TXX-4260

COMANCHE PEAK STEAM ELECTRIC STATION  
UNITS 1 AND 2  
ADDITIONAL QUESTIONS RELATIVE TO PROTECTIVE  
COATINGS ALLEGATIONS  
FILE NO. 906.1, 10010

QUESTIONS RELATIVE TO ALLEGATION NO. 21

Attachment A

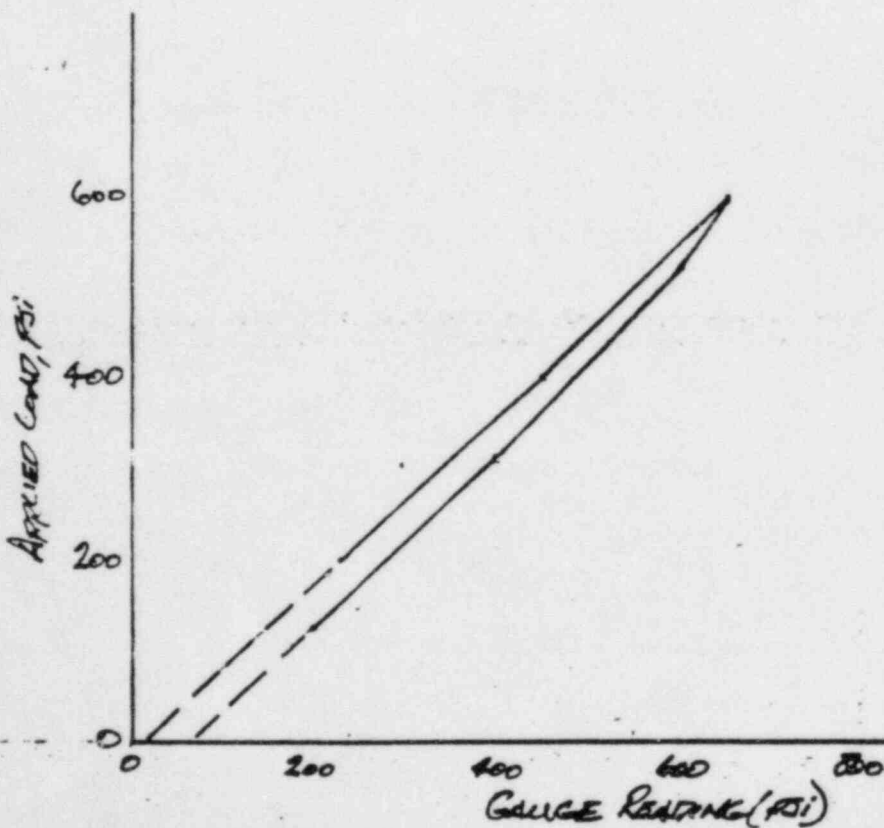
Test No. 1 - Set testers at 0, 200, 400 and 600 psi and read applied load on proving ring

Test No. 3 - Apply 0, 200, 400 and 600 psi to proving ring and read gauges

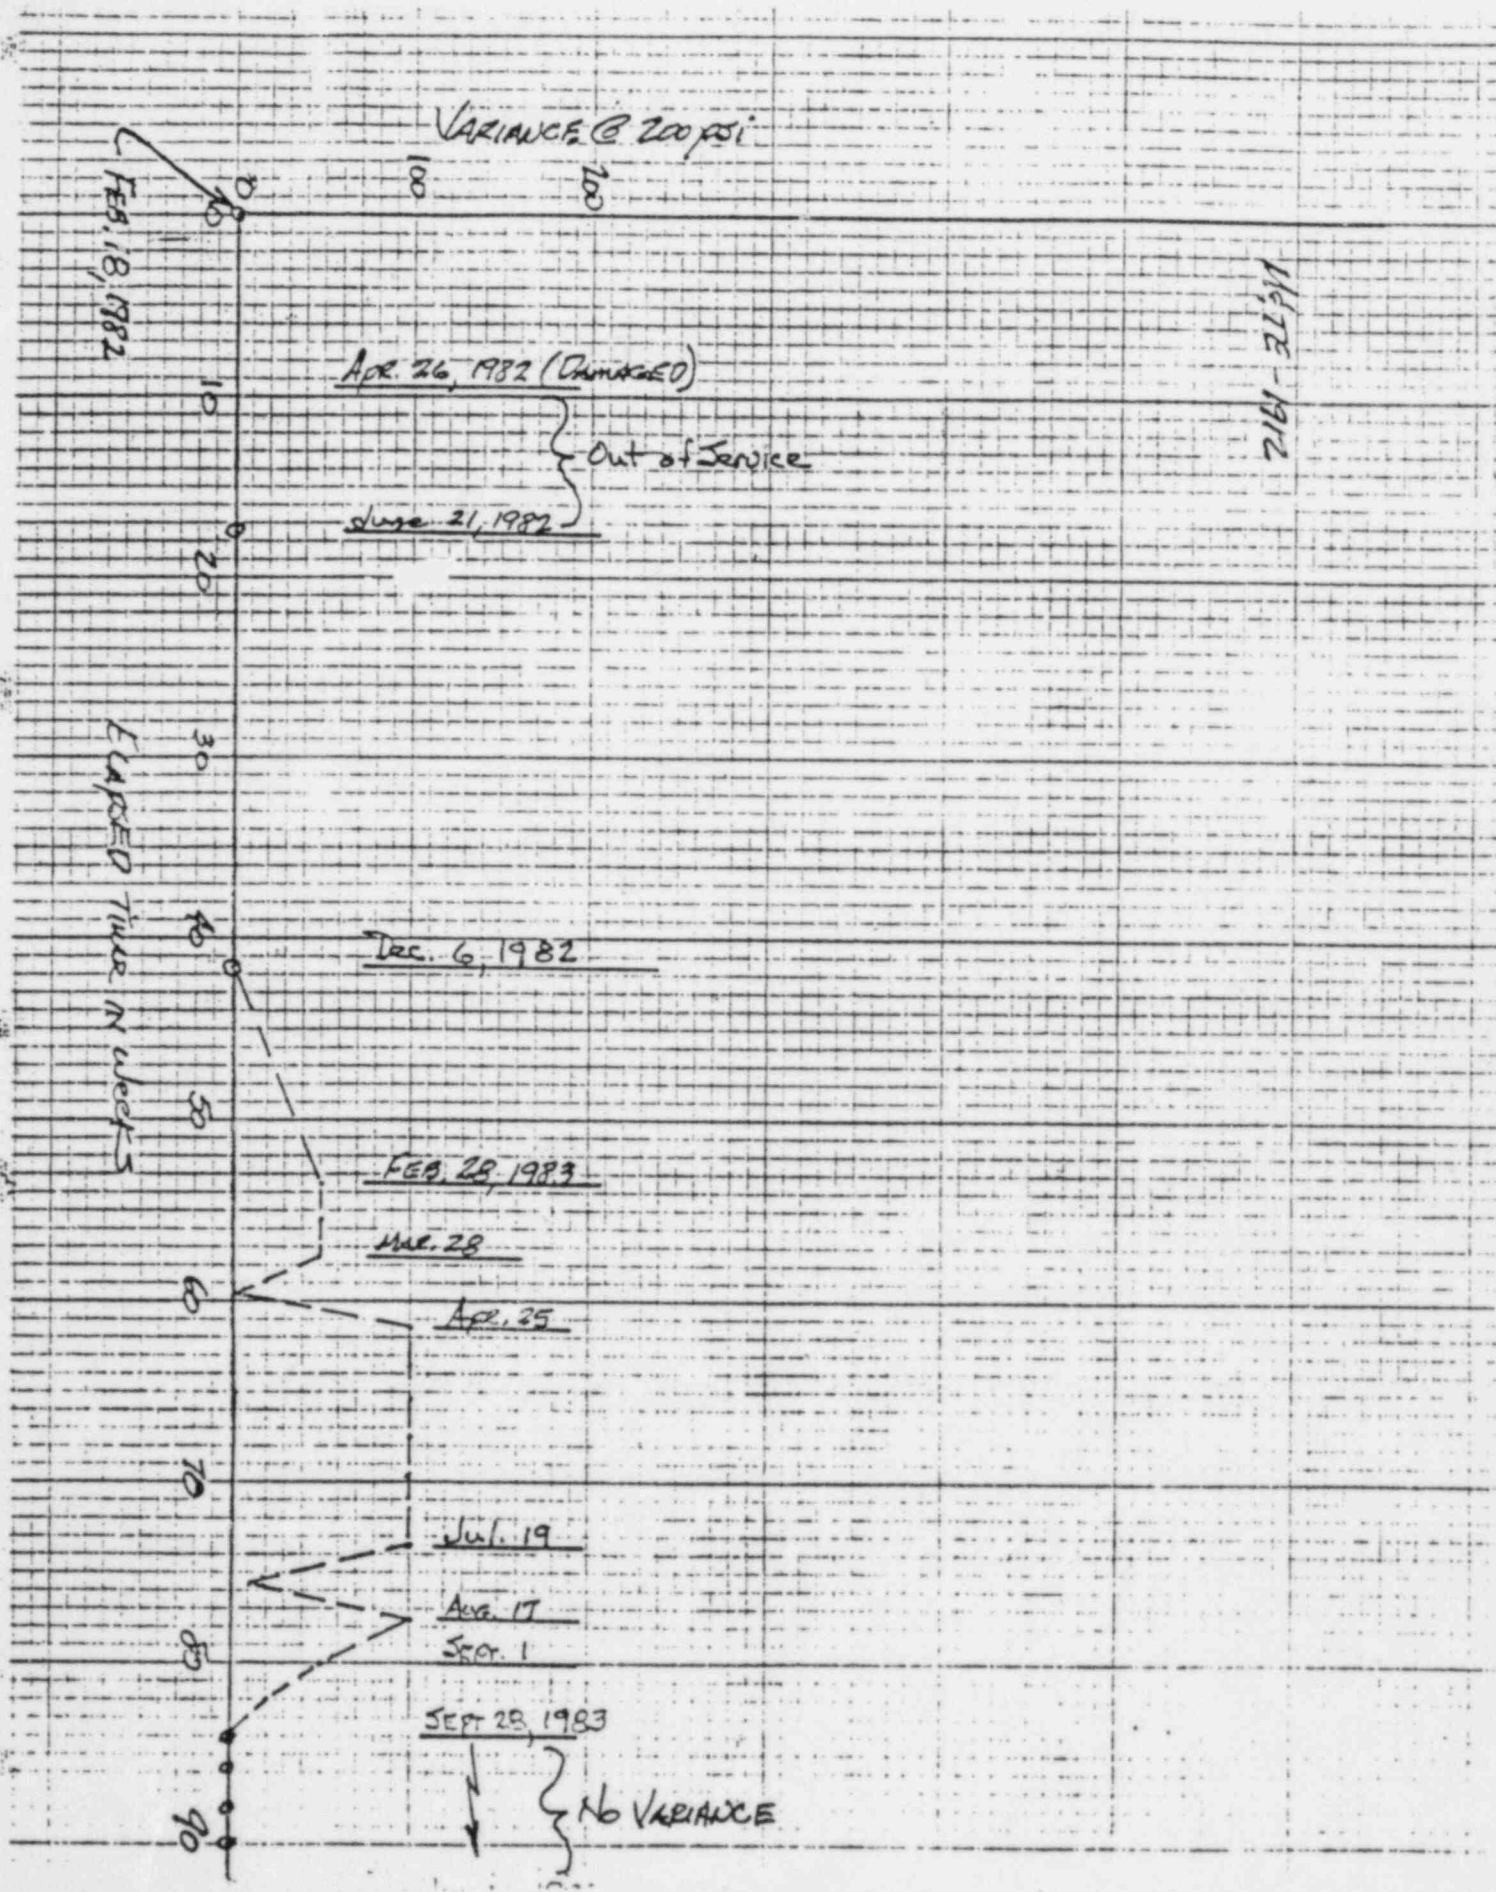
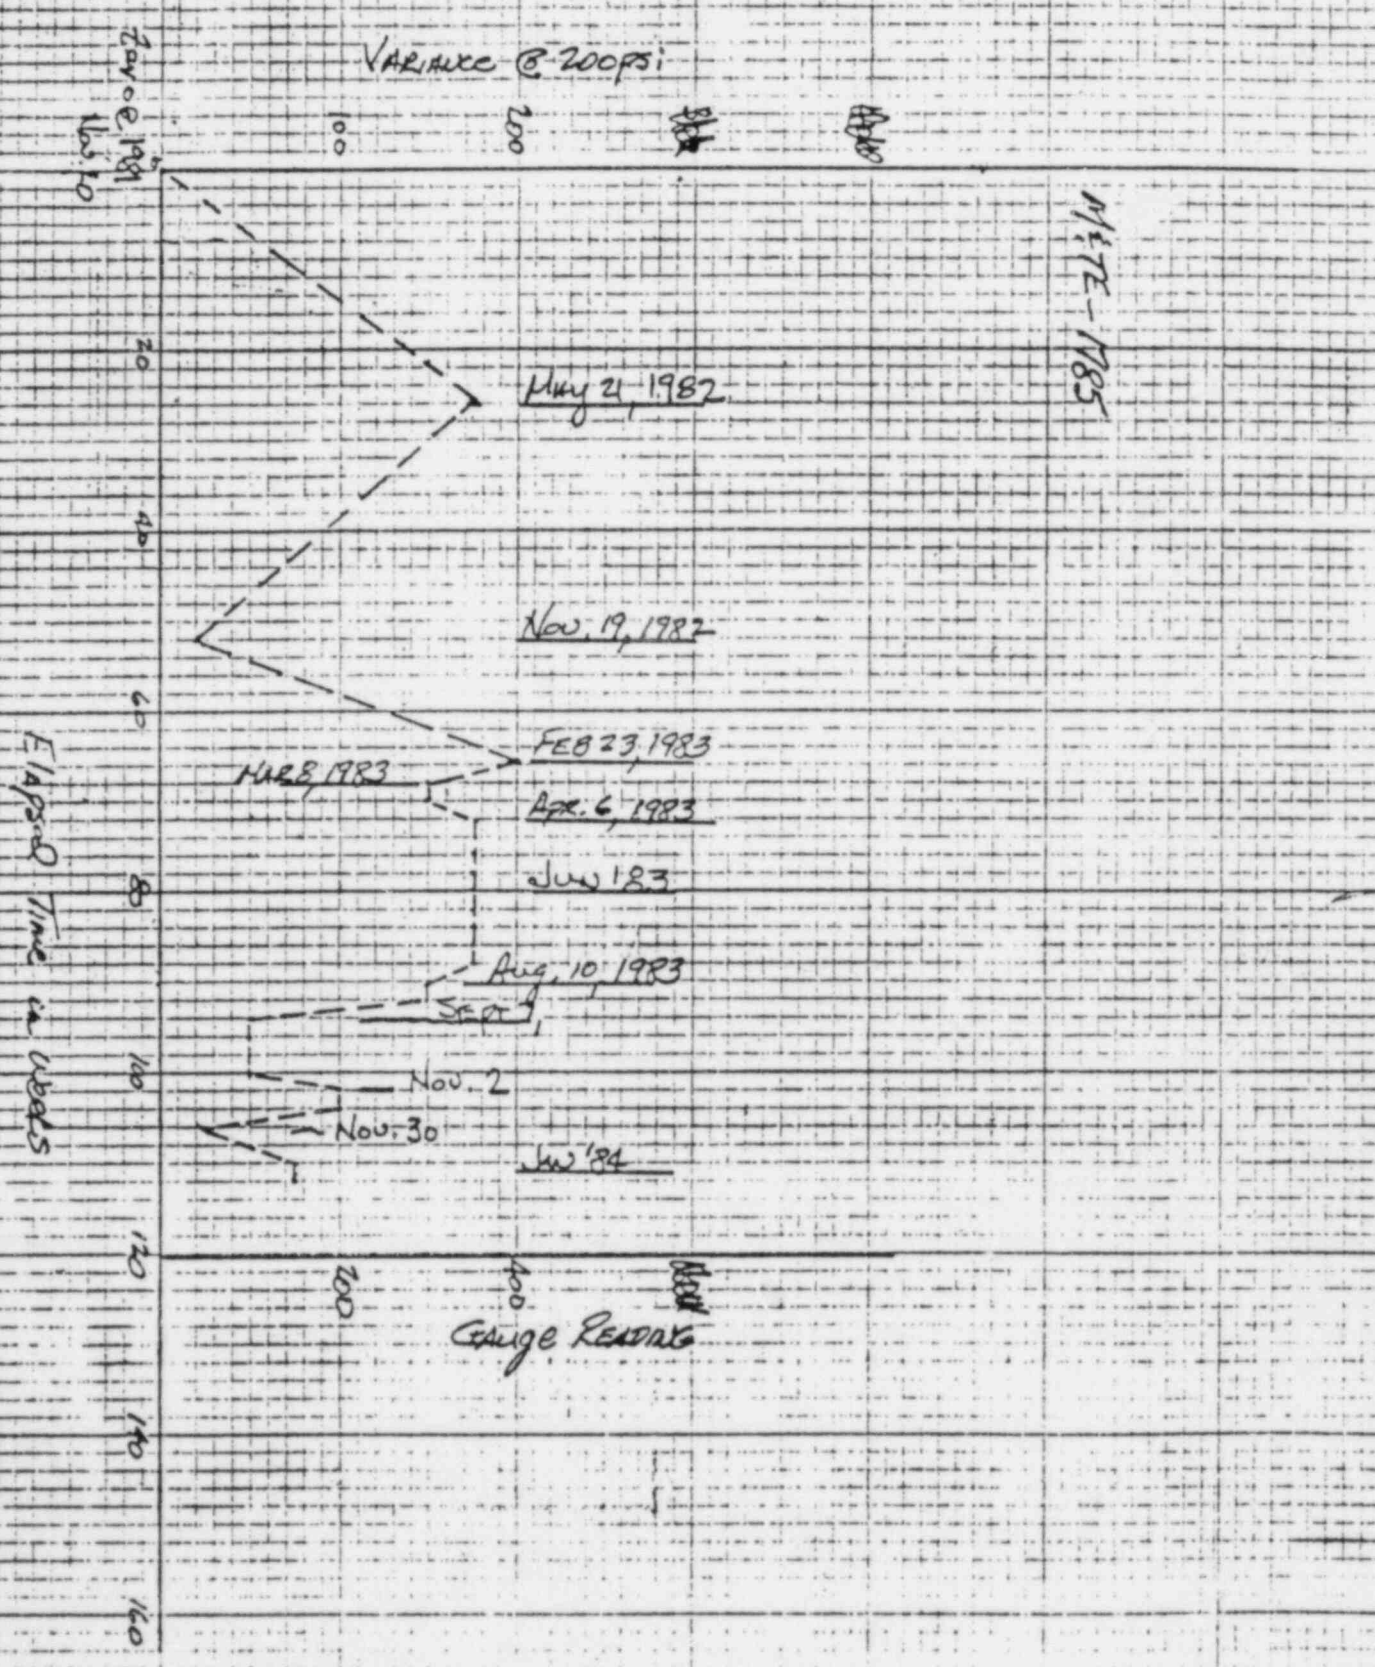
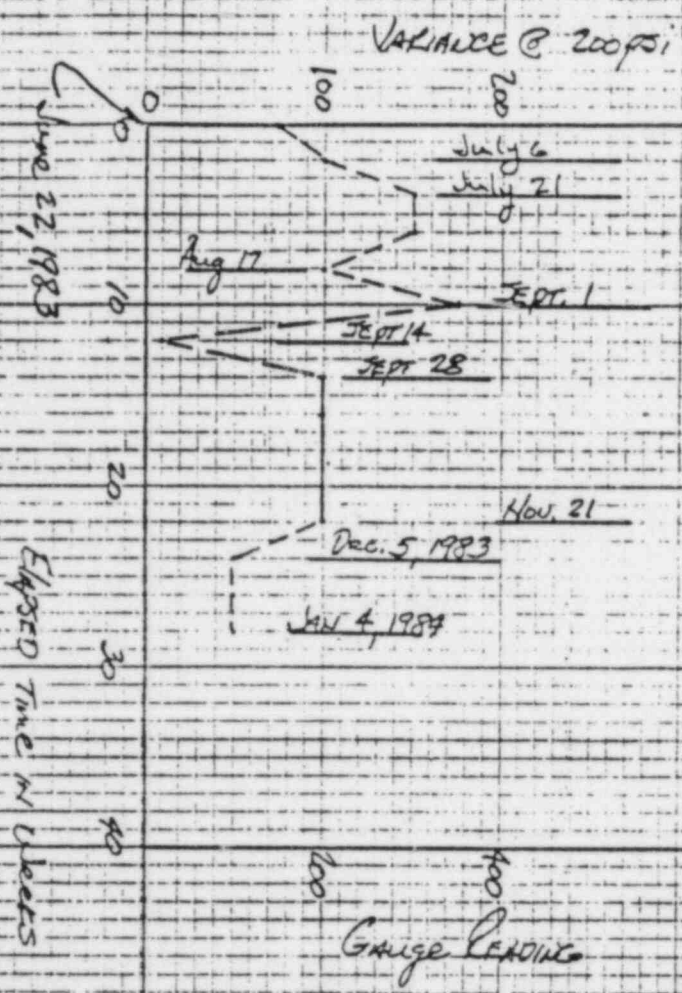
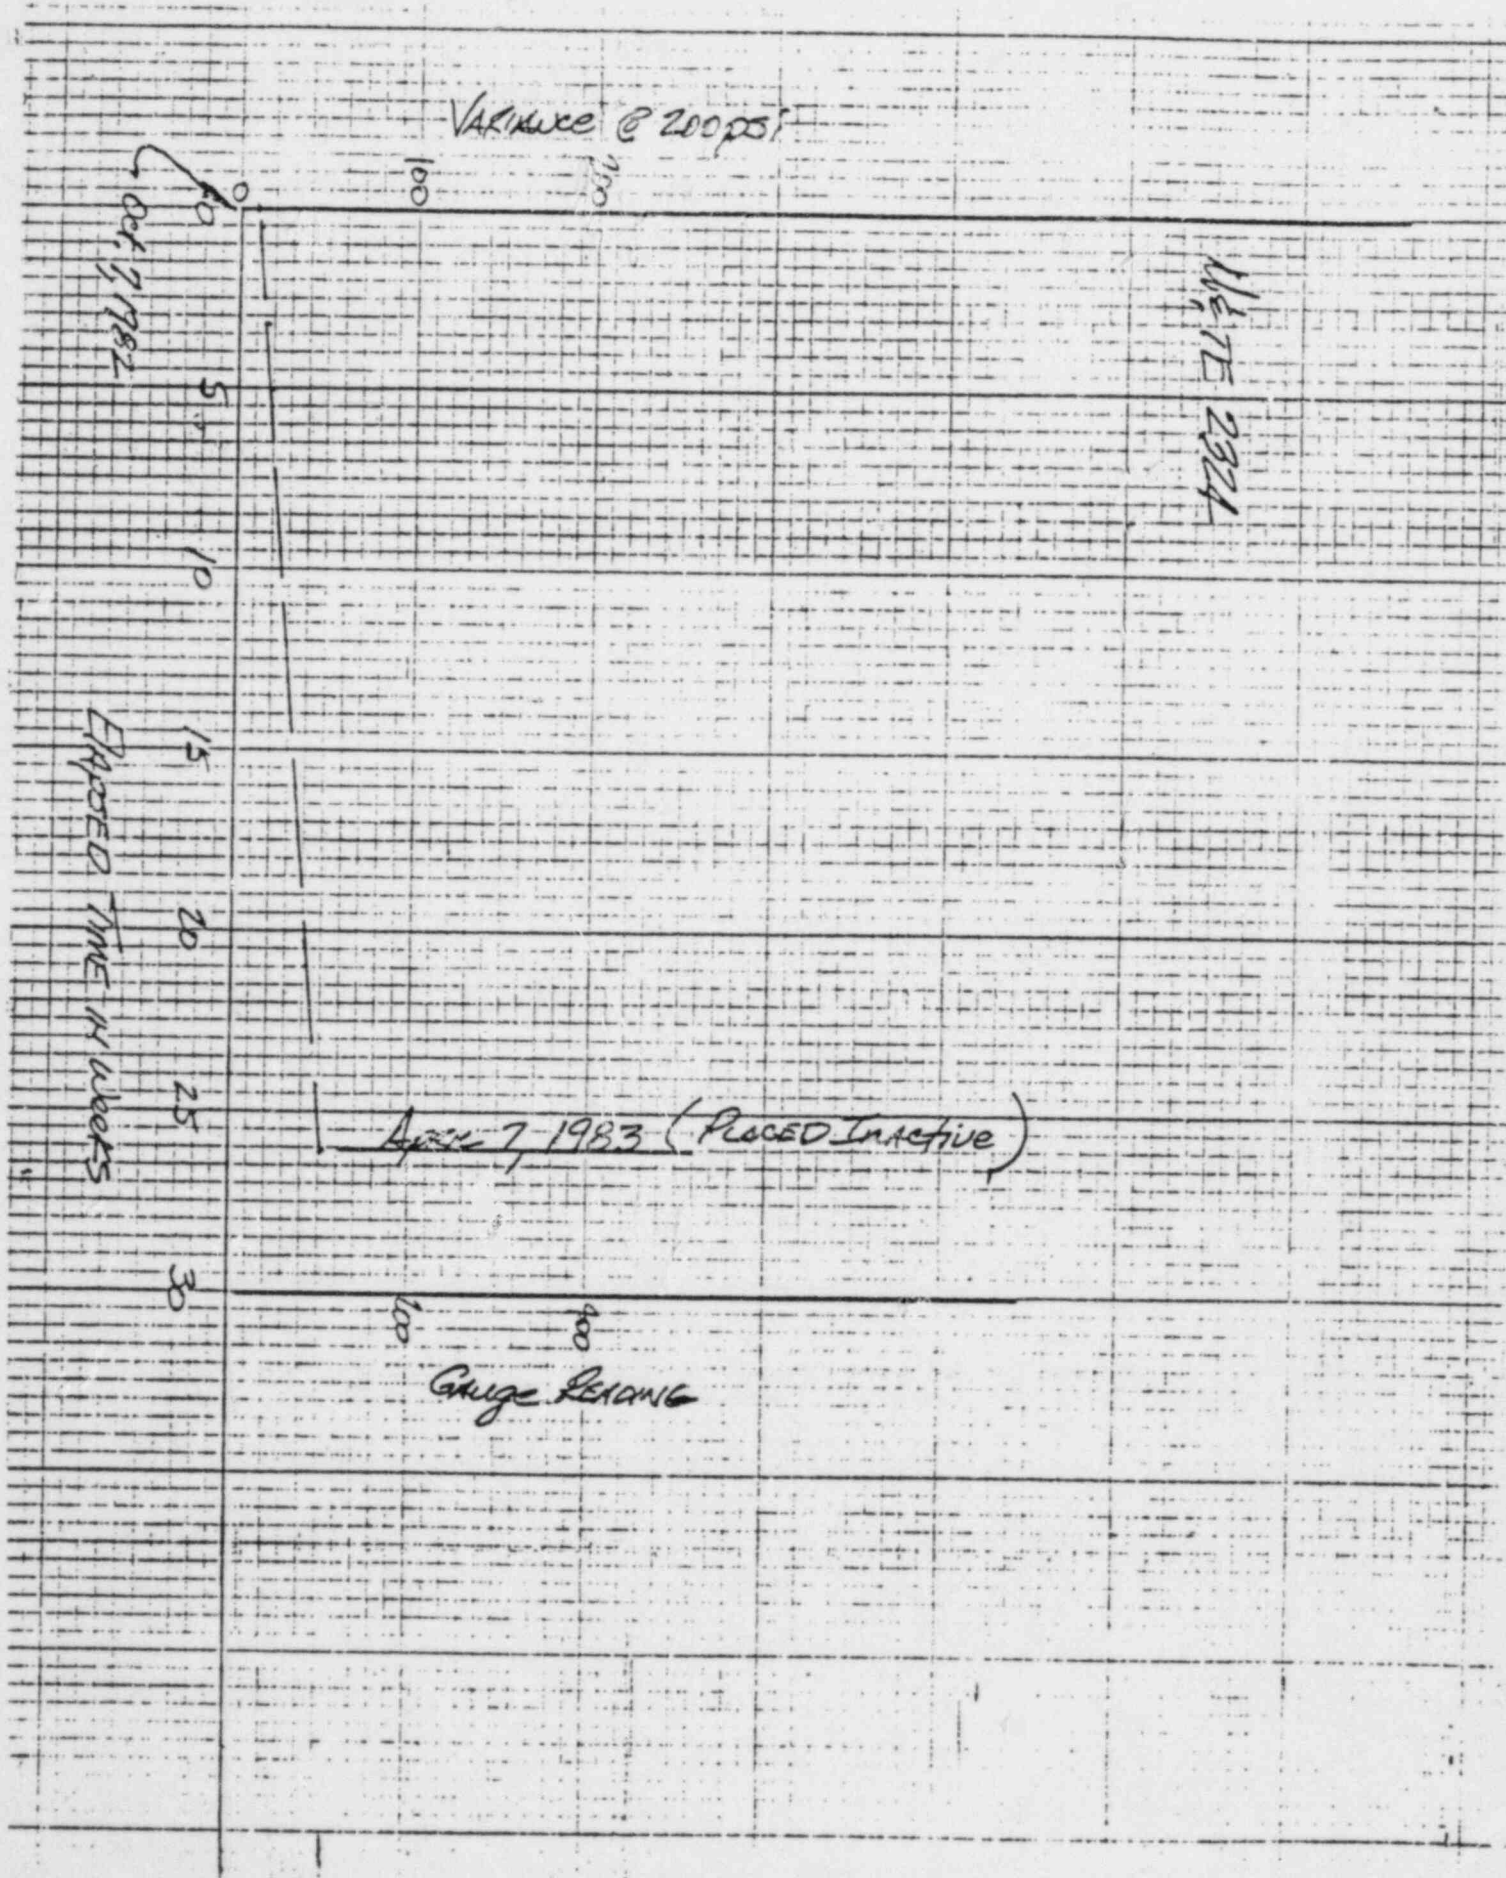
4. Corrected readings for the sample area (Field reading - largest positive deviation during calibration period).
- b. For each Elcometer used in the Backfit program, provide a table or curve showing calibration deviations (at the 200 psi point value) as a function of date for the complete Backfit period. In case the instrument zero required adjustment show deviations before and after adjustment.

b) Copies of the plotted calibration records discussed in our meeting of July 11, 1984 are attached.
